RE: **Agenda Item C.4, December 4, 2023, Regular Council – Land Use Meeting**  
**Development Application No. 7919-0177-00**  
**11037, 11049, 11057 and 11069 Ravine Road, 11054, 11066 and 11080 - 132 Street**

City of Surrey  
**ADDITIONAL PLANNING COMMENTS**

Application No.: 7919-0177-00

## RESPONSE SUBMISSION TO ADP COMMENTS

2 PLAYGROUND SECTION  
 Scale 1:50

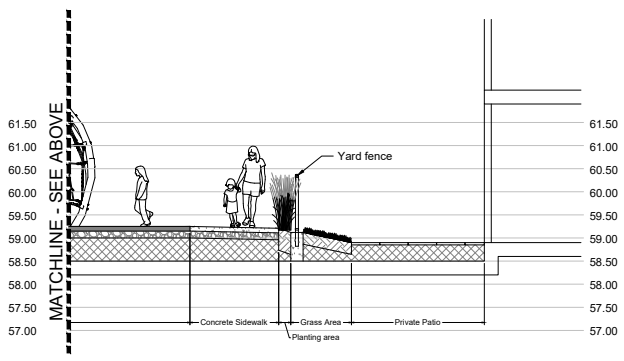
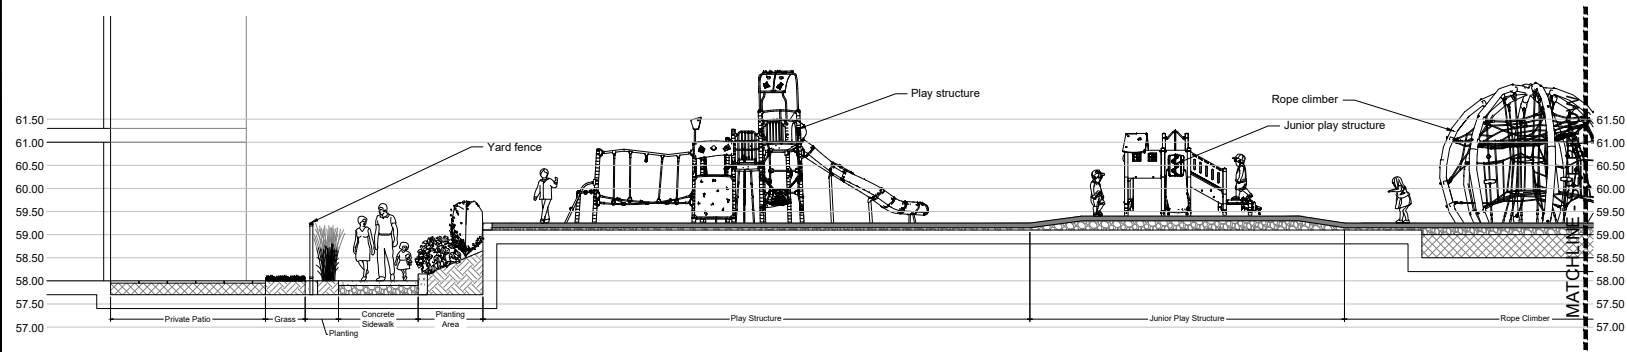
- Sheet L04D section 2 shows narrow strip of sod on a slope with a planting area that appears to be less than 300mm width. Recommend increasing planting bed and soil depth to allow for adequate separation and privacy of private patios at playground. This section is cut through the accessible
